NORTHERN STATES POWER COMPANY

PRAIRIE ISLAND NUCLEAR GENERATING PLANT  
Docket No. 50-282 License No. DPR-42  
50-306 DPR-60

Supplemental Information - License Amendment Request  
dated January 31, 1980

SPENT FUEL STORAGE CAPACITY MODIFICATION

FIGURE A-1  
Spent Fuel Pool Water Supplies

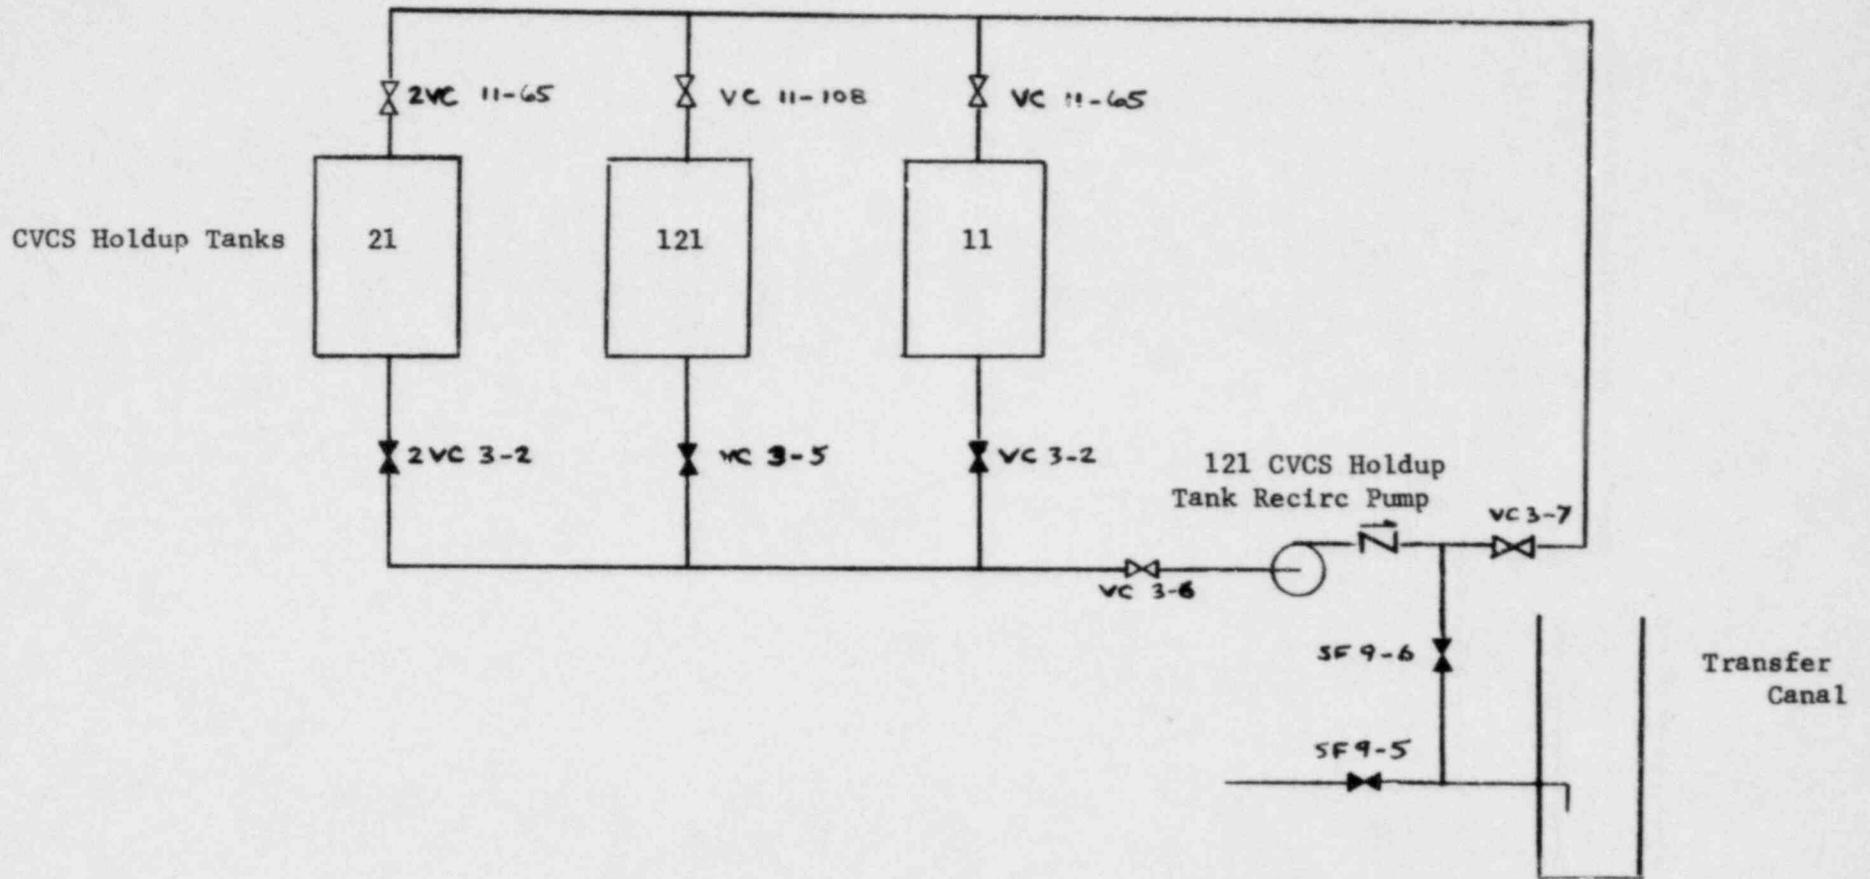
Figure A-1 shows the CVCS holdup tank supply path to the spent fuel transfer canal. This system is Class I and is permanently piped. The 121 Recirc pump has a nonsafeguards power supply. The pump is rated in excess of 300 gpm. Lineup may be made in less than 10 minutes since the pump and all related valves are in the gas stripper feed pump room and the pump control switch is just outside this room. Existing procedures cover this option.

FIGURE A-2

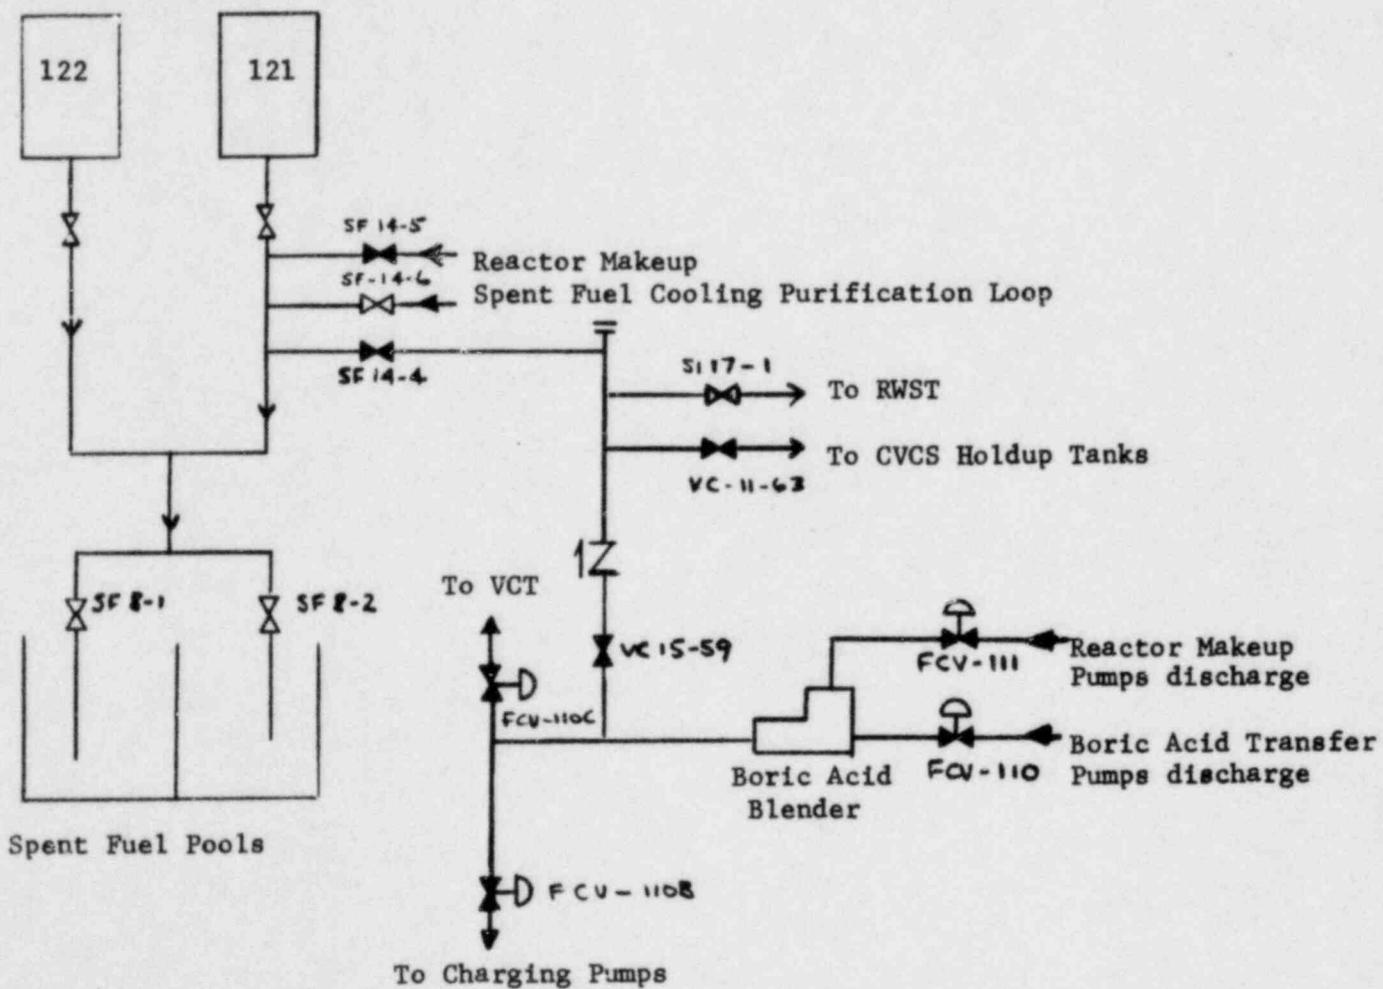
Figure A-2 shows an alternate flow path that can be used. Valves VC-15-59 and SF-14-4 would need to be opened and the blender flow adjusted (in the control room) for manual makeup. Blended flow at up to 100 gpm is possible. This flow path can be lined up in less than 10 minutes. This flow path is Class I up to SF-14-4. Existing procedures cover this option.

FIGURE A-3  
Spent Fuel Pool Water Supplies

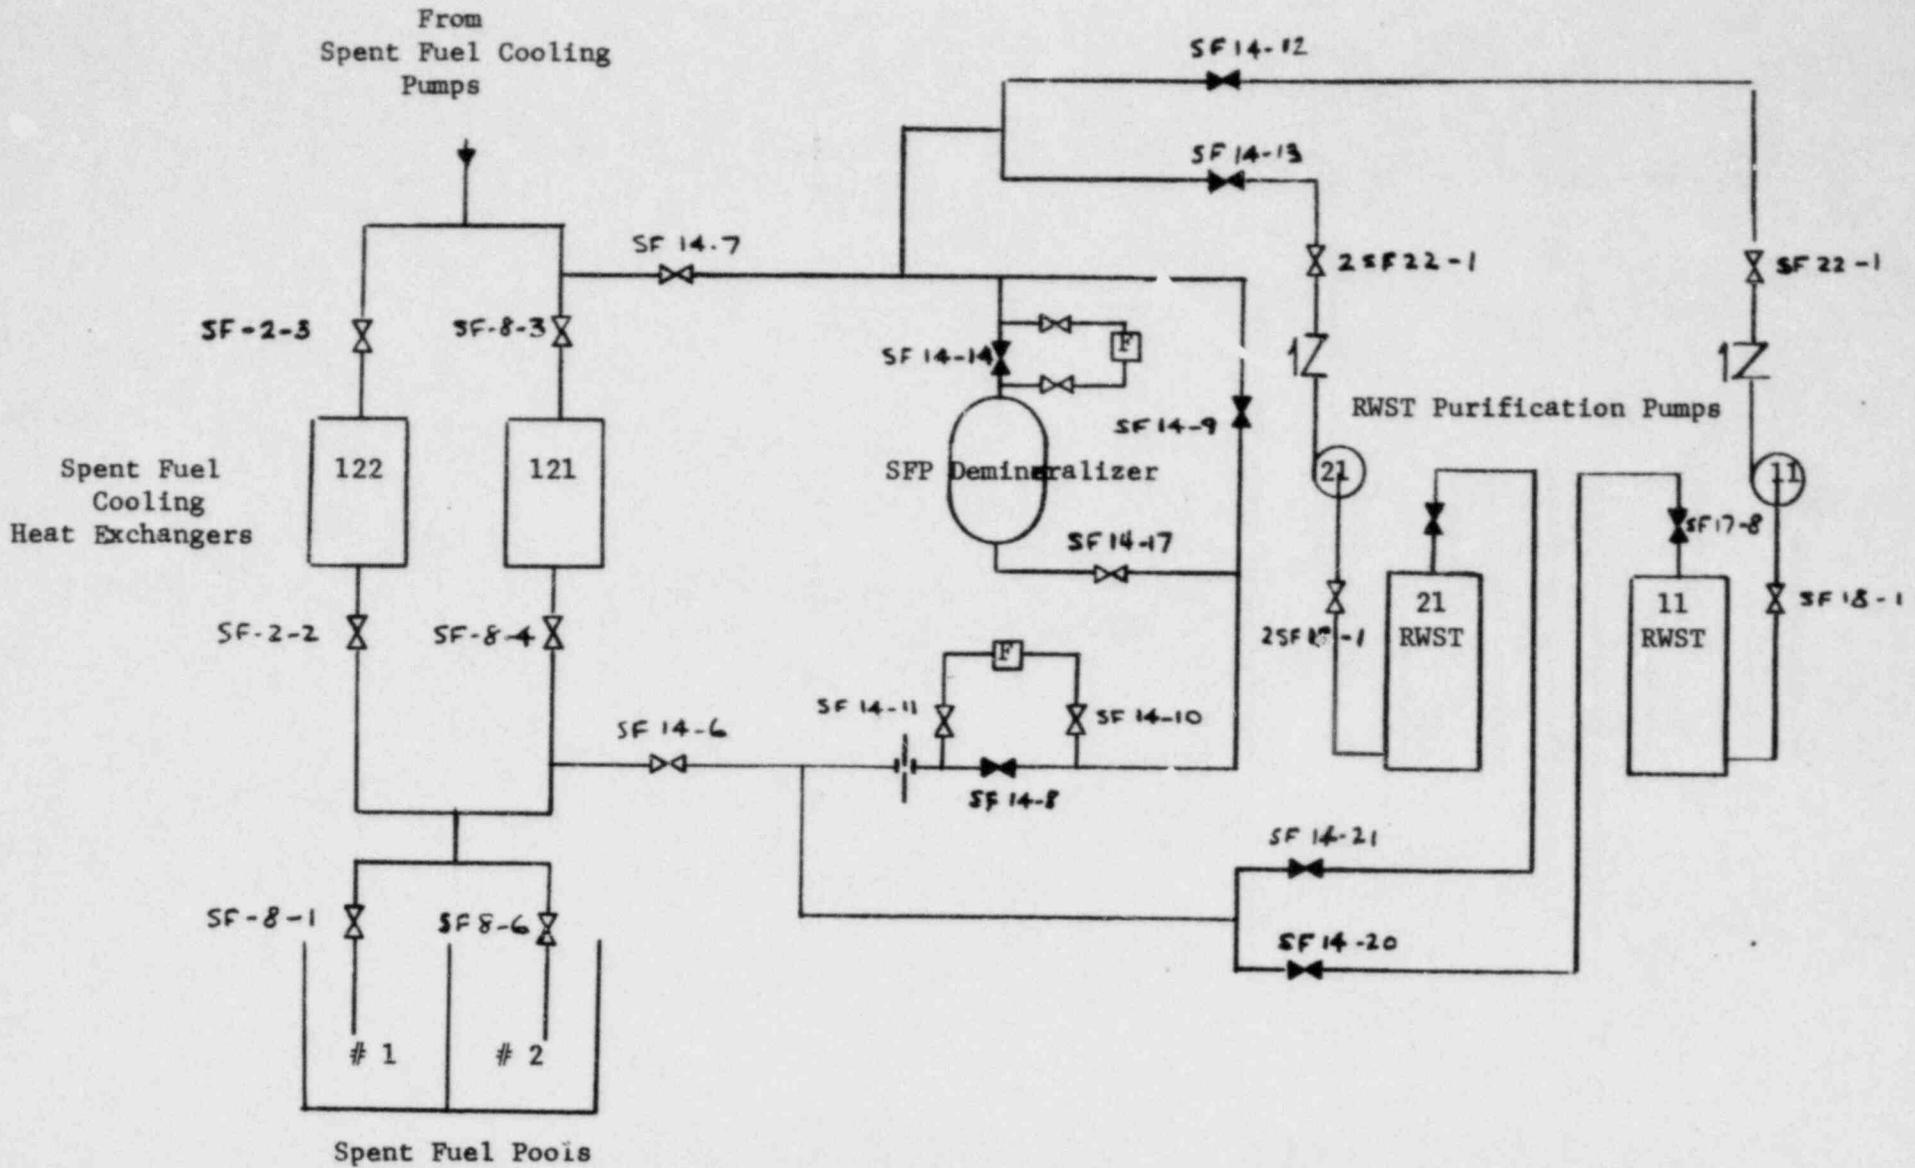
Figure A-3 illustrates the flow paths from either unit's RWST to the spent fuel pool. This system is permanently piped but is not Class I. Design flow of 80 gpm at 180 ft pressure could be provided by the refueling water purification pump. To lineup this flow path would involve opening 3 valves, closing 1 valve, verifying 1 valve closed, and starting the refueling water purification pump. This lineup may be achieved in less than 10 minutes. Existing procedures cover this option.

FIGURE A-4  
Spent Fuel Pool Water Supplies

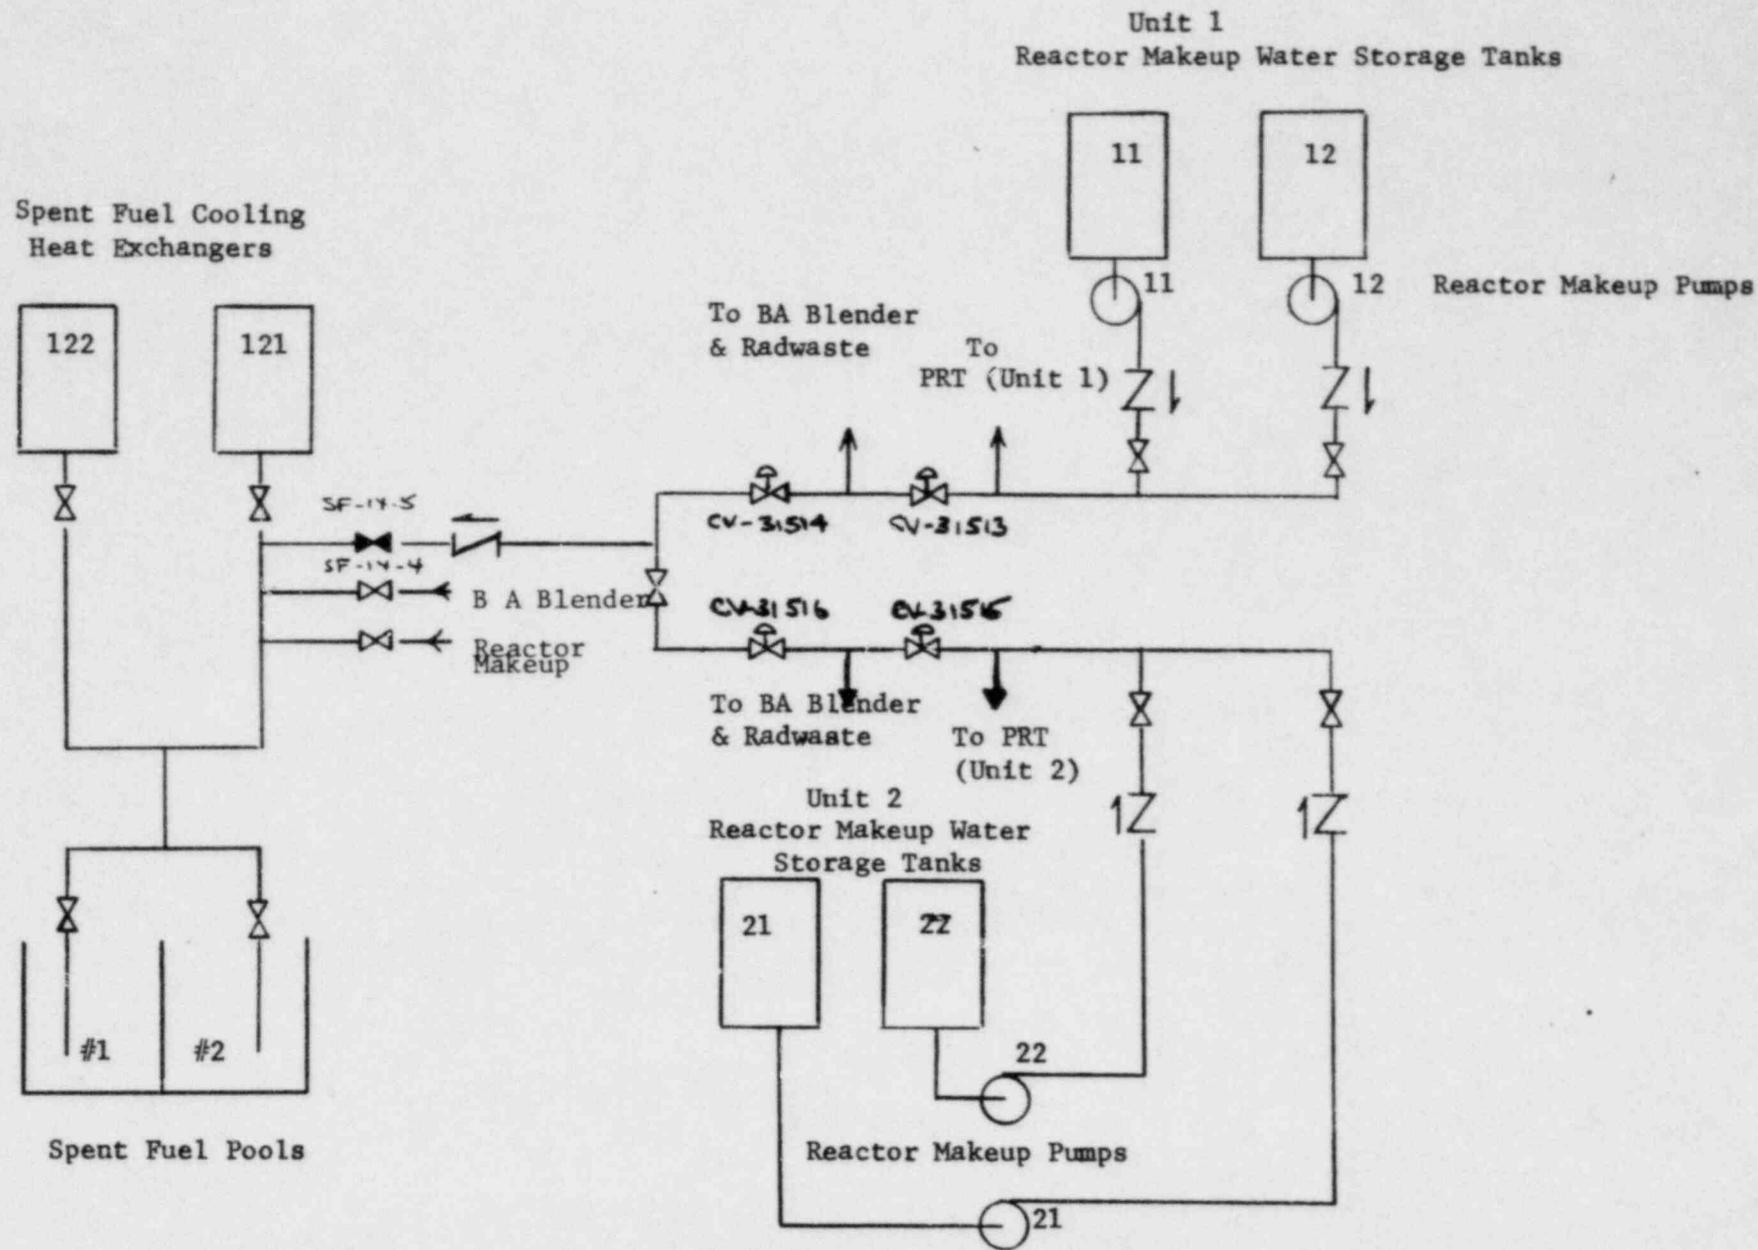
Figure A-4 illustrates the flow paths from either unit's reactor makeup storage tanks to the spent fuel pool. The system is permanently piped, but is not Class I. The reactor makeup pumps have nonsafeguards power supplies. Each reactor makeup water pump is capable of supplying water at 80 gpm at 83 psi pressure. Only 1 valve needs to be opened to supply water to the spent fuel pool. This lineup can be made in less than 10 minutes. Existing procedures cover this option.

FIGURE A-5  
Fuel Handling Building

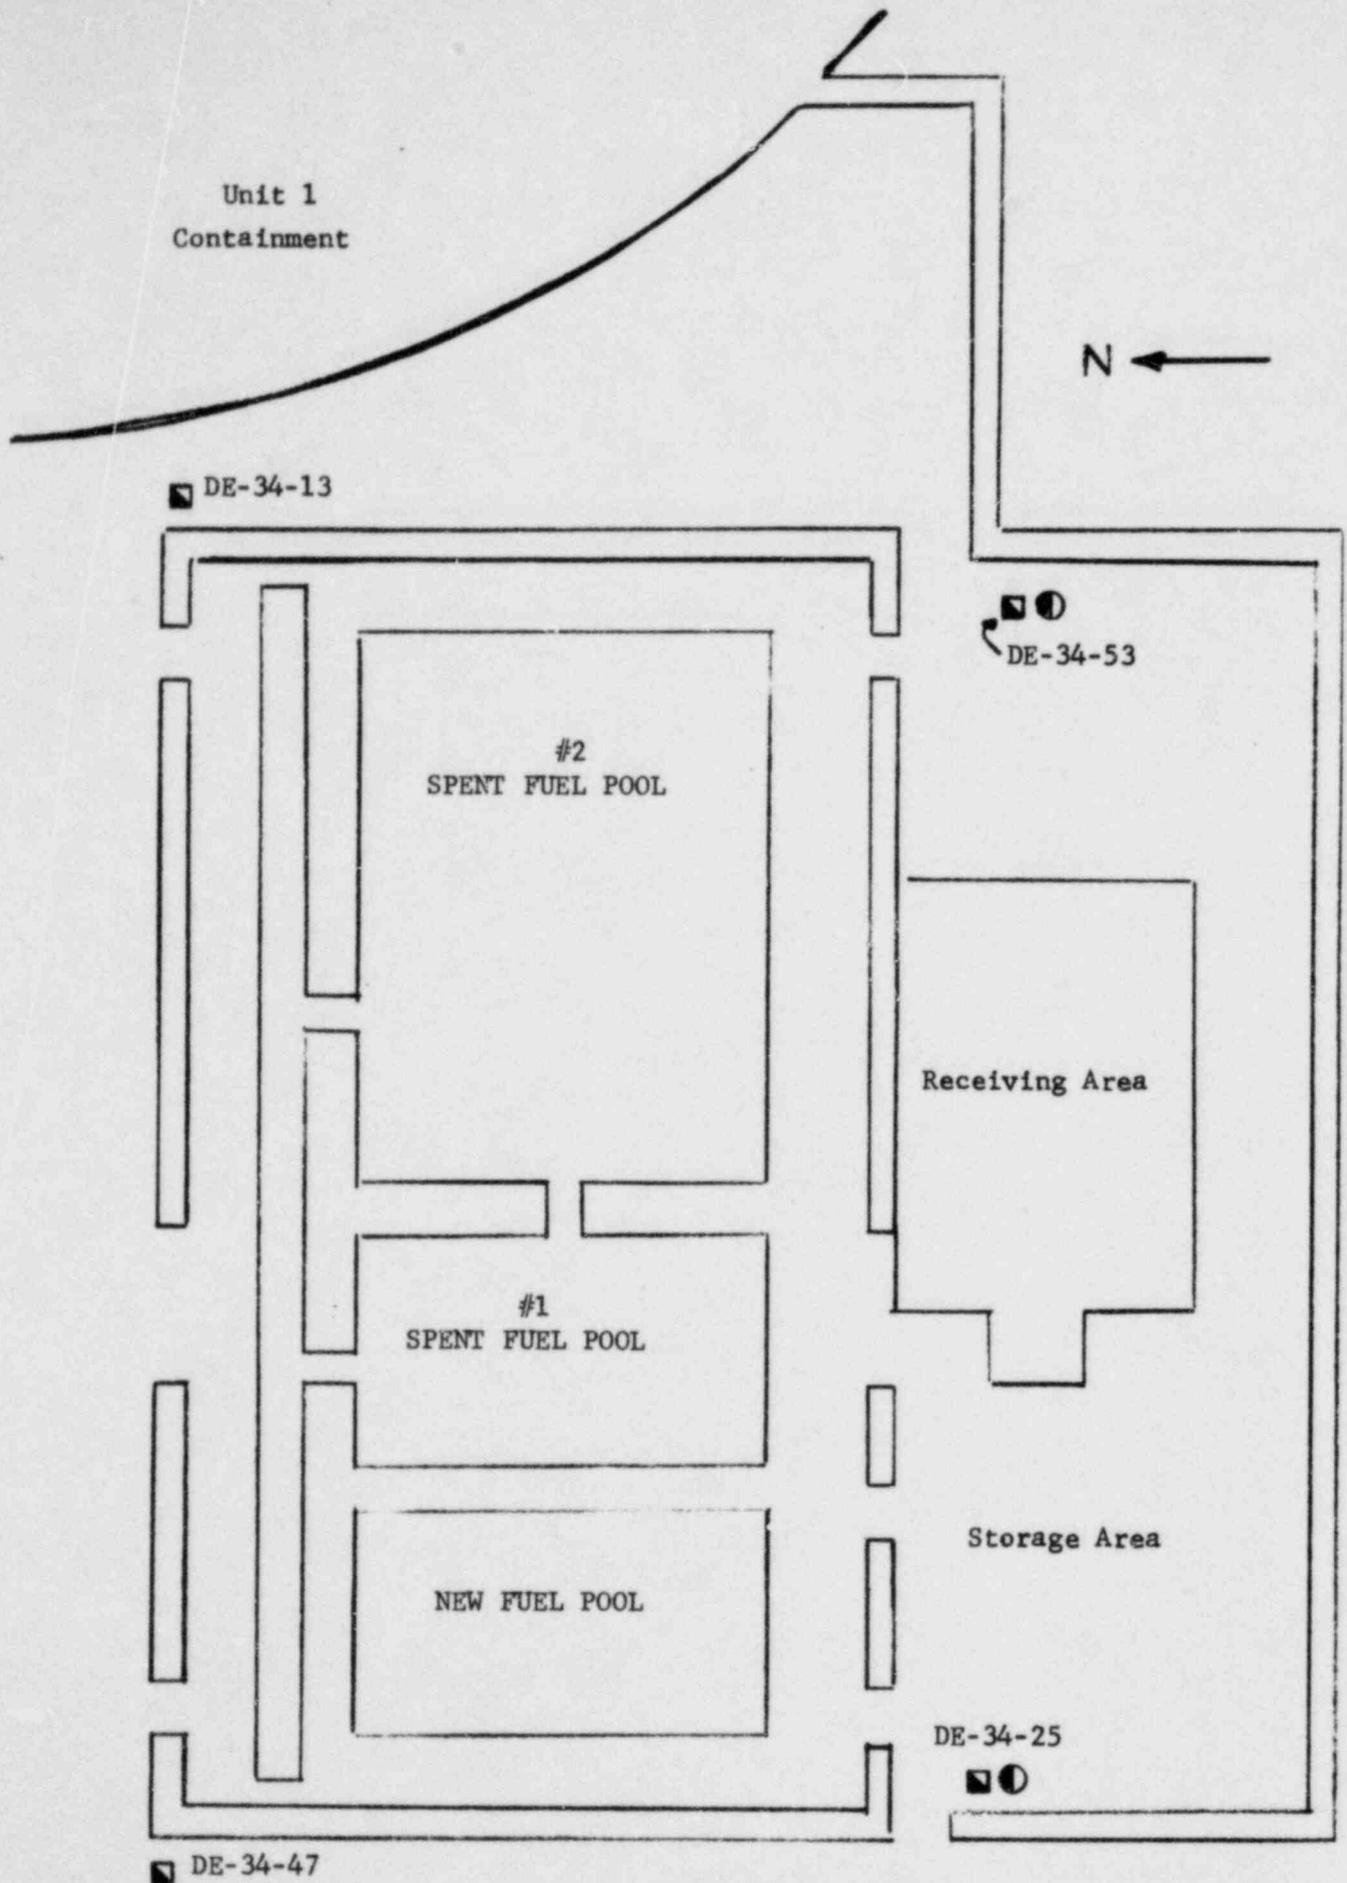
There are 4 demineralized water (non Class I) hose stations near the spent fuel pools, as shown on Figure A-5. Each hose station is rated at approximately 20 gpm. To supply water to the spent fuel pool, a demineralized water hose is simply connected and the supply valve opened. Such an operation would take less than 10 minutes. Note also on Figure 4 of Exhibit A that demineralized water can be supplied to the discharge side of the SFP demineralizer.

There are 2 fire hose stations near the spent fuel pools, as shown on Figure A-5. This system is not Class I.
